Site Accessibility Evaluation

Peak Vista - Jet Wing

1815 Jet Wing Dr
Colorado Springs, CO
80916

Accessibility Evaluation

Finding: 2

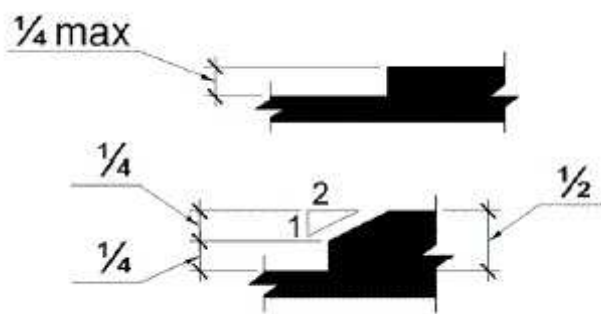
The parking stall contains abrupt edges and surface irregularities over a 1/4 inch vertical.

Contains abrupt edges
and cracking of
asphalt

Parking lot needs to be resurfaced or crack filled and re-striped.

Finding: 3

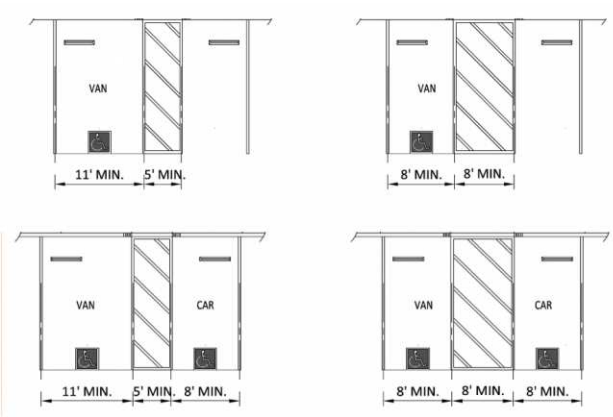
The accessible parking stall is not wide enough.

Van parking stall only
measures 93 inches in
width

Parking lot needs to be resurfaced or crack filled and re-striped.

Finding: 4

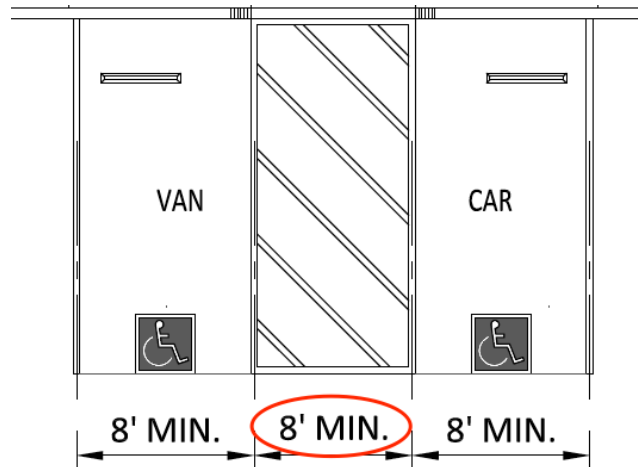
The access aisle is not a minimum 8 feet to the centerline of the stripe.

Van access aisle only
92 inches in width

Parking lot needs to be resurfaced or crack filled and re-striped.

Finding: 5

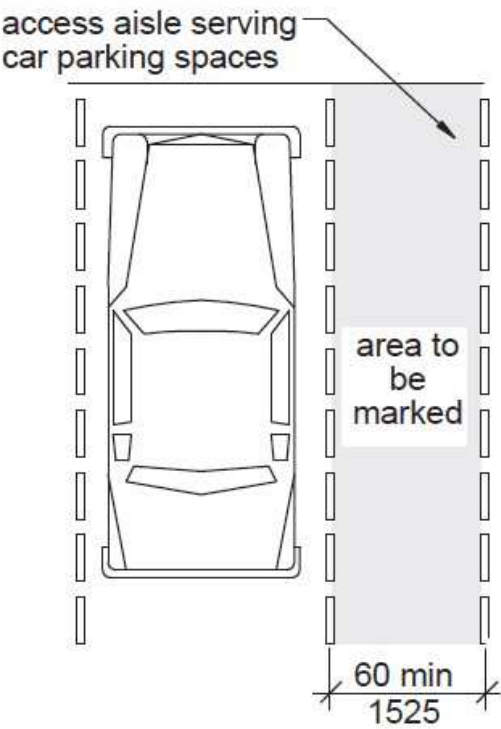
The access aisle is not a minimum 5 feet wide.

Both access aisles
between 55 and 56
inches in width

Parking lot needs to be resurfaced or crack filled and re-striped.

Finding: 6

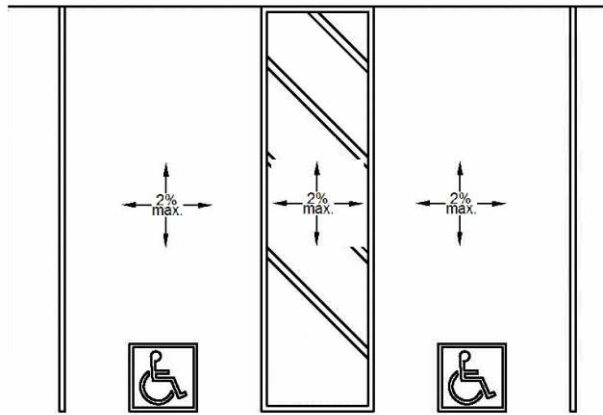
The cross slope (narrow dimension) of the parking stall exceeds 2%.

One of the van access
aisles cross slope
ranges between 2.27%
- 2.79%

Parking lot needs to be resurfaced or crack filled and re-striped.

Finding: 7

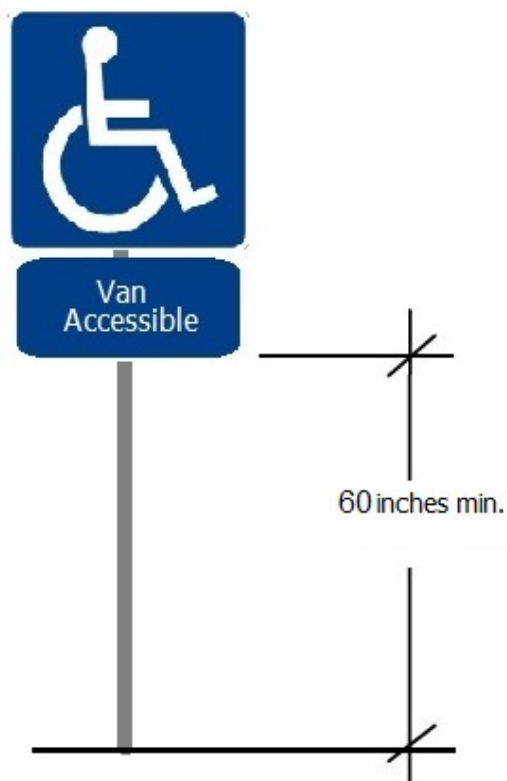
The parking sign is mounted too low.

All accessible parking signs measure below 60 inches above finished floor

Adjust height on all parking signs to a minimum of 60 inches measured from the bottom edge of the sign to finished floor or ground

Finding: 8

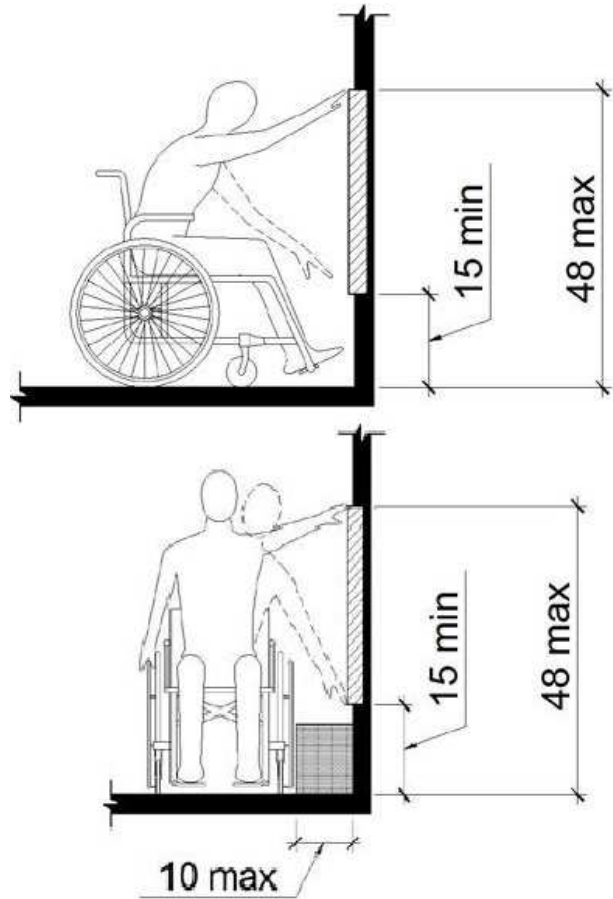
The hand sanitizer dispenser's operation mechanism is too high off the floor.

54 inches above
finished floor to
operable part

Lower hand sanitizer 7 inches minimum not to exceed a maximum height of 48 inches above finished floor.

Finding: 9

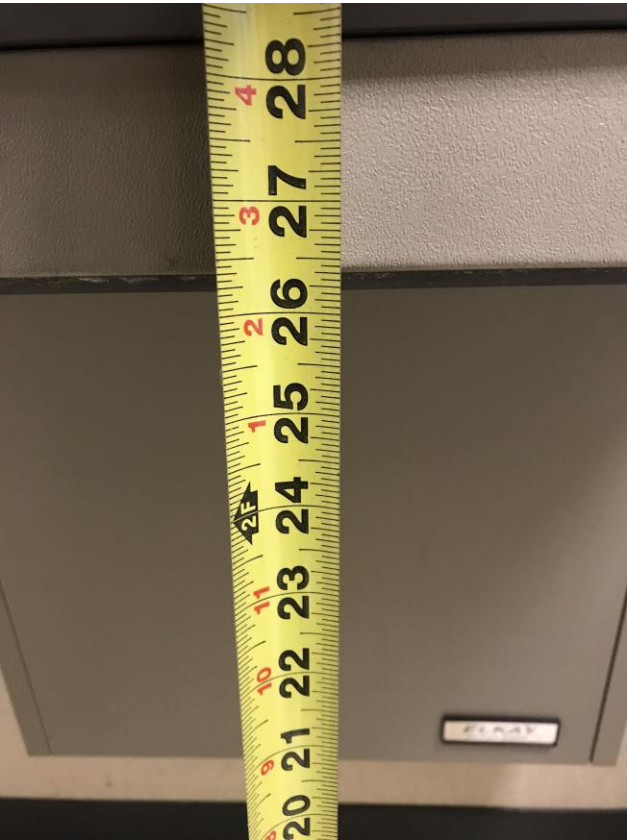
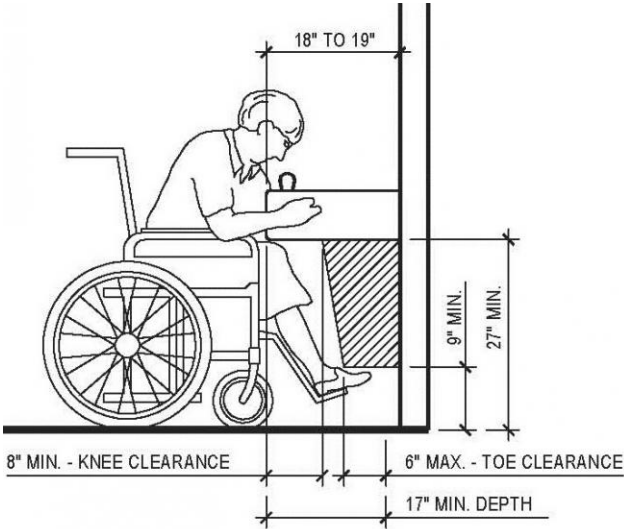
There is not enough knee clearance under the drinking fountain.

26.25 inches above
finished floor to
bottom edge of
drinking fountain

Adjust drinking fountain height to provide exactly 27 inches of clearance from the bottom edge above finished floor.

Finding: 12

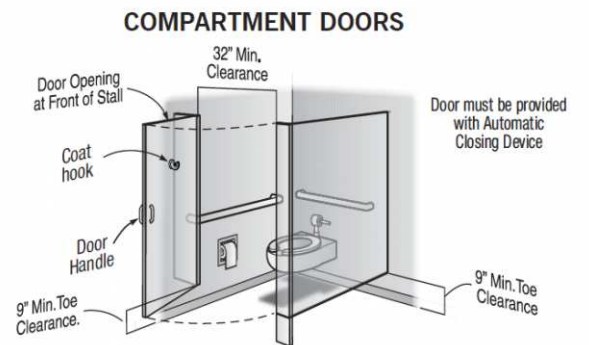
The compartment door is not self closing.

Compartment door
does not fully close

Adjust or install automatic closing hinges.

Finding: 13

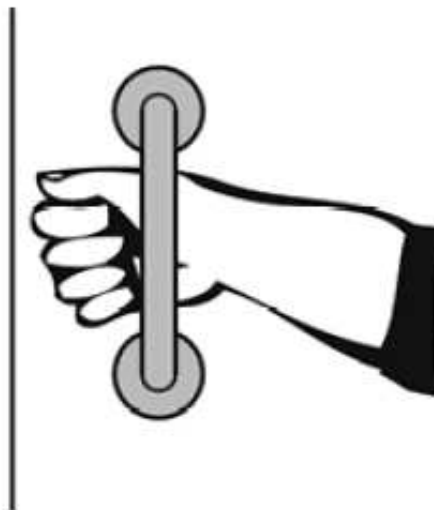
The water closet compartment door is missing a loop handle.

Missing both loop handles

Install loop or U-shape handles on the inside and outside of the compartment door.

Finding: 14

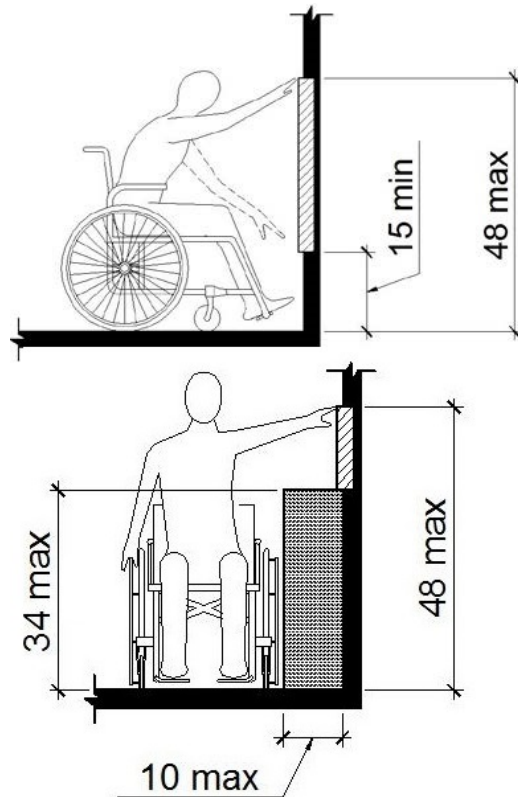
The coat hook is installed greater than 48 inches above the finished floor.

65.75 inches above
finished floor

Lower coat hook 19 inches minimum or install another coat hook not to exceed a maximum height of 48 inches above finished floor.

Finding: 15

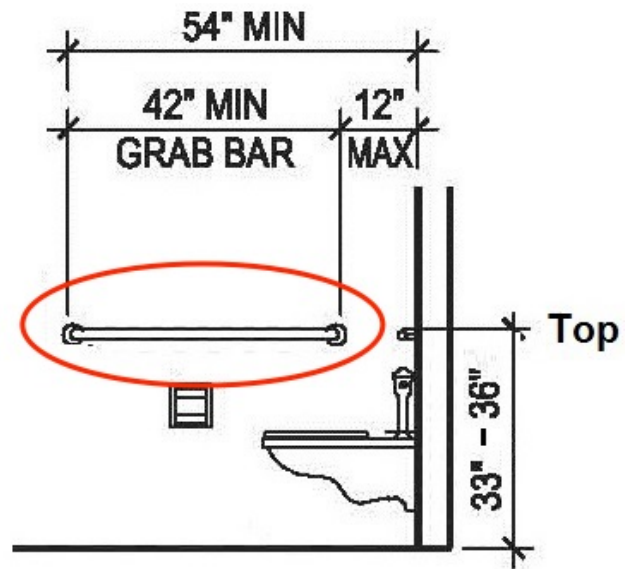
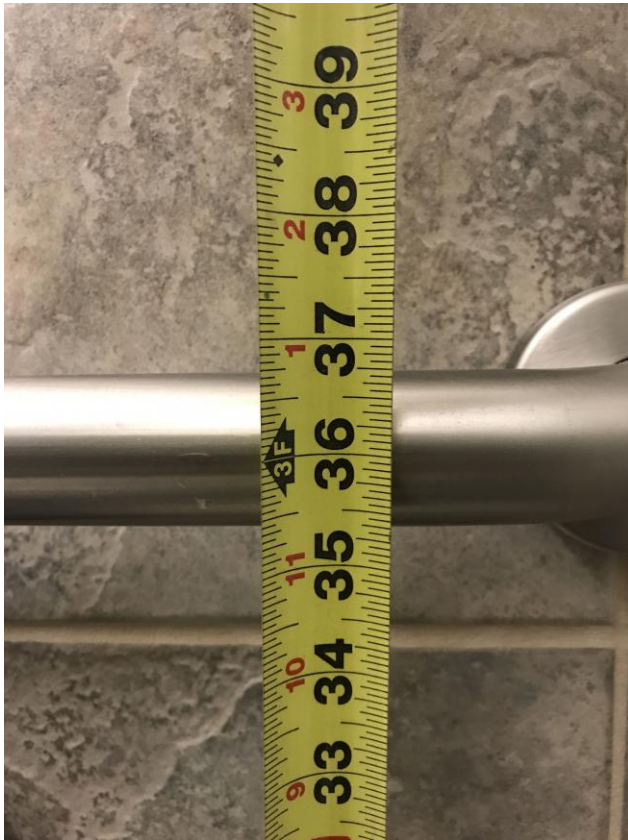
The side grab bar is too high.

36.75 inches above
finished floor

Reposition grab bar in a horizontal position 33 inches minimum and 36 inches maximum above the finished floor measured to the top of the gripping surface.

Finding: 16

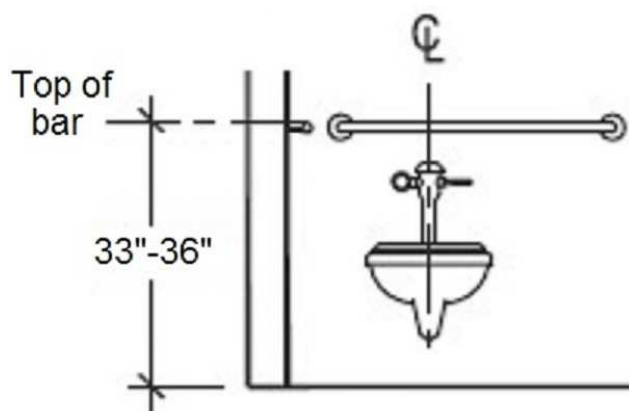
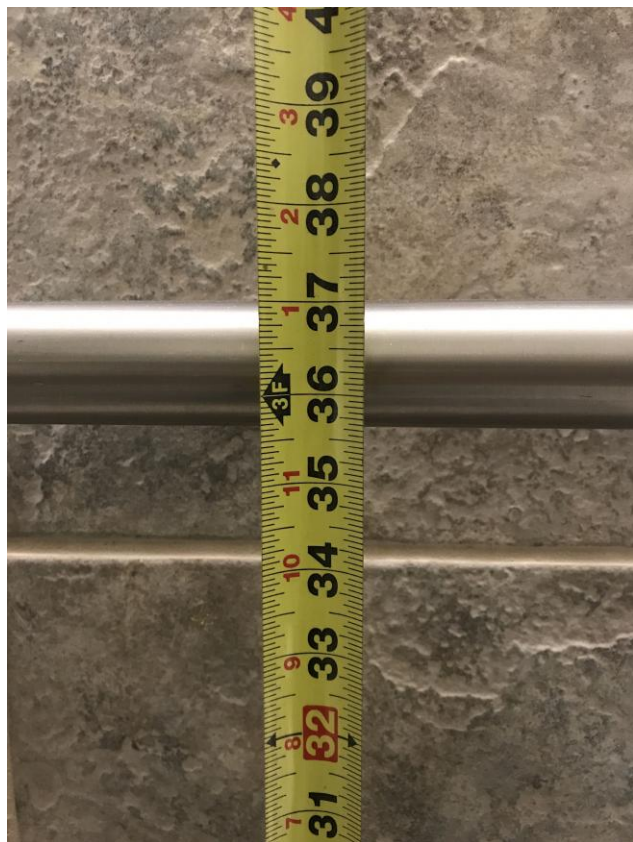
The rear grab bar is too high.

37 inches above
finished floor

Reposition grab bar in a horizontal position 33 inches minimum and 36 inches maximum above the finished floor measured to the top of the gripping surface.

Finding: 17

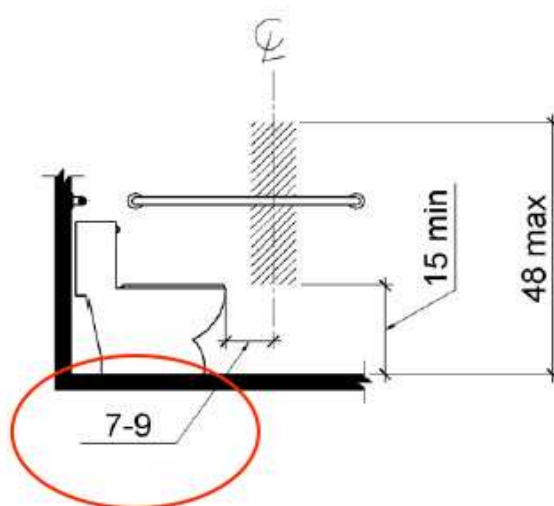
The toilet paper is not installed within the compliant range.

10 inches in front of toilet

Re-position toilet paper dispenser to be within 7 inches minimum to 9 inches maximum in front of the toilet measured to the centerline of the dispenser.

Finding: 18

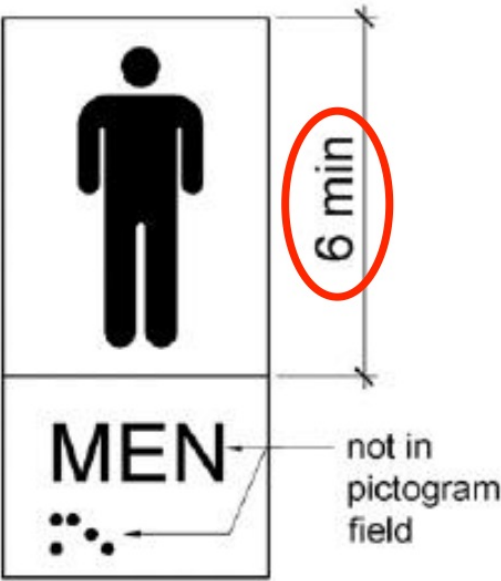
The pictogram field height on the sign is not 6 inches minimum.

Pictogram field only
measures 5 inches

Replace sign with compliant pictogram field of no less than 6 inches in height.

Finding: 19

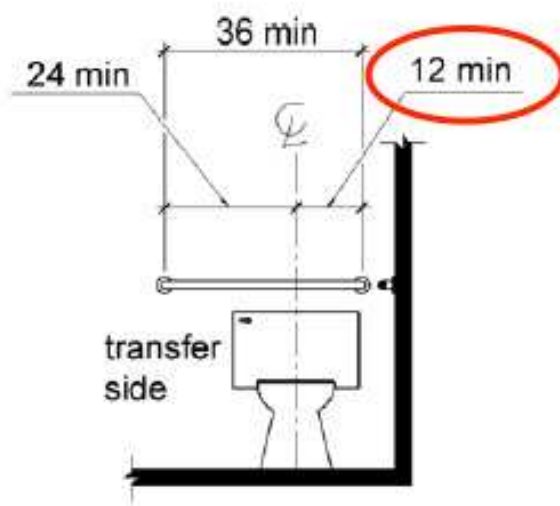
The rear grab bar does not extend adequately past the centerline of the toilet on the wall side.

Extends 10.75 inches
past the centerline the
toilet on the wall side

Re-position rear grab bar to extend from the centerline of the toilet 12 inches minimum to the wall side and 24 inches minimum to the transfer/open side.

Finding: 22

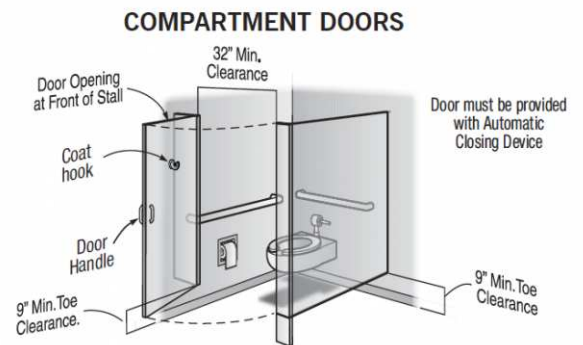
The compartment door is not self closing.

Compartment door
does not fully close

Adjust or install automatic closing hinges.

Finding: 23

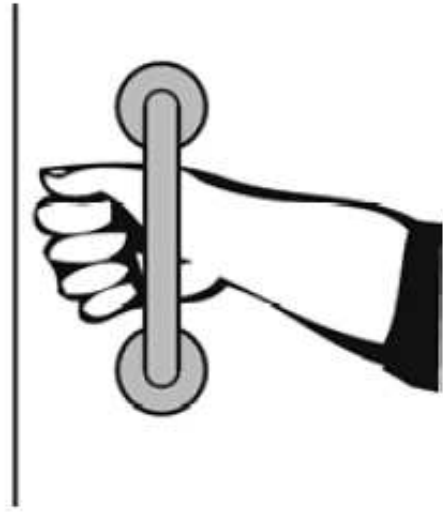
The water closet compartment door is missing a loop handle.

Missing both loop handles

Install loop or U-shape handles on the inside and outside of the compartment door.

Finding: 24

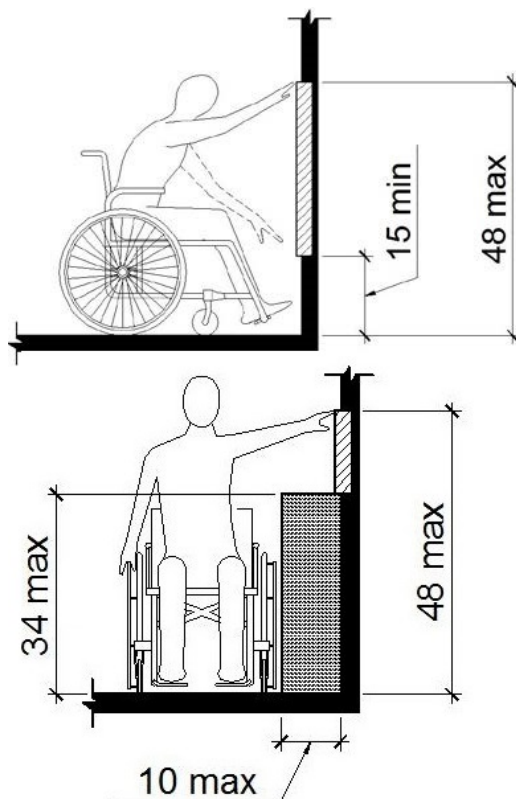
The coat hook is installed greater than 48 inches above the finished floor.

65.75 inches above
finished floor

Lower coat hook 19 inches minimum or install another coat hook not to exceed a maximum height of 48 inches above finished floor.

Finding: 25

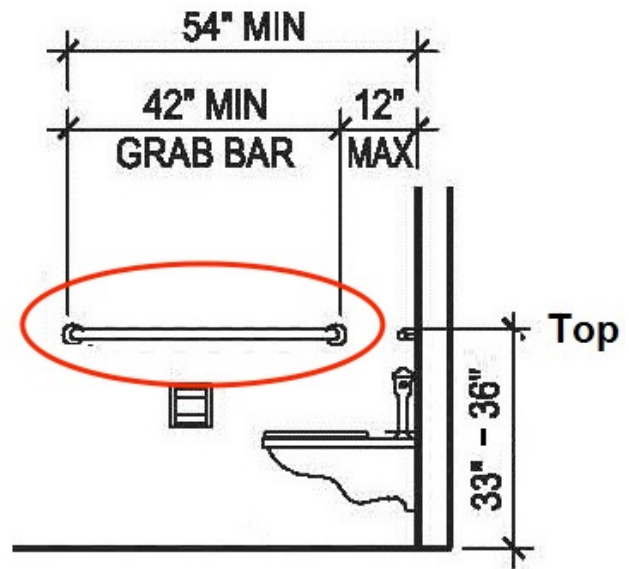
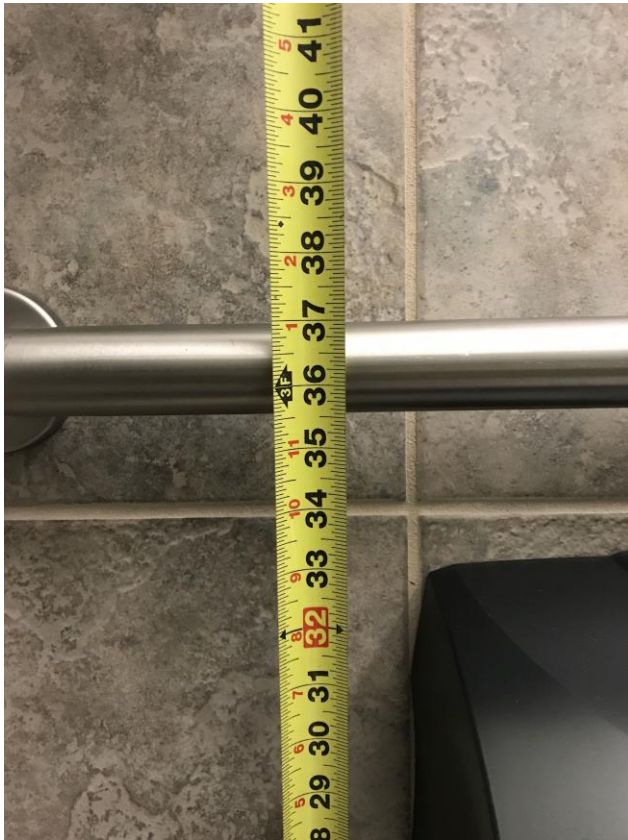
The side grab bar is too high.

37 inches above
finished floor

Reposition grab bar in a horizontal position 33 inches minimum and 36 inches maximum above the finished floor measured to the top of the gripping surface.

Finding: 26

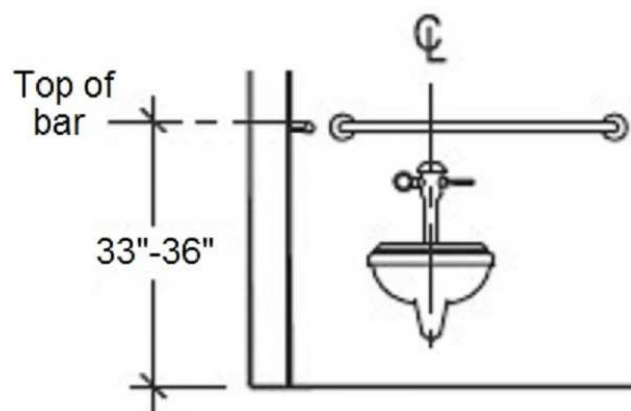
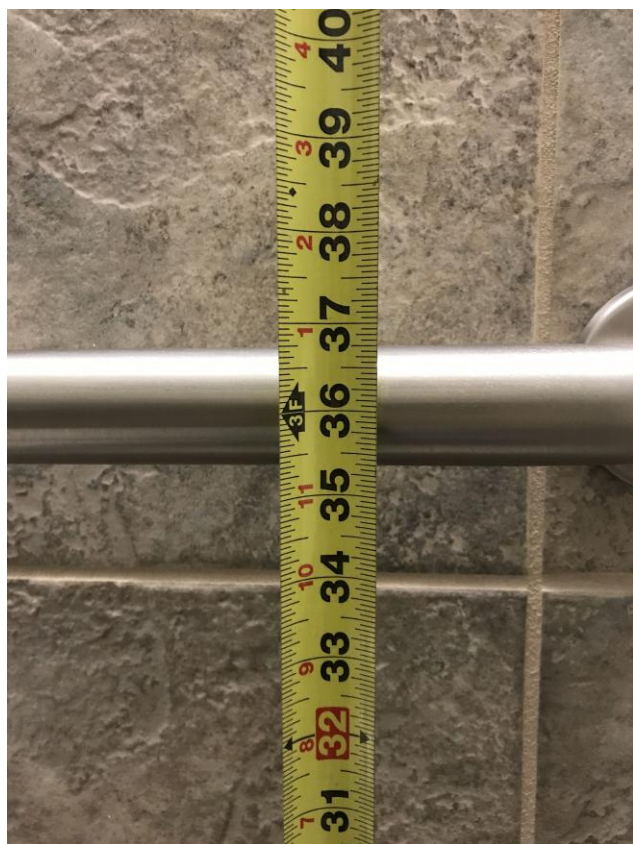
The rear grab bar is too high.

36.75 inches above
finished floor
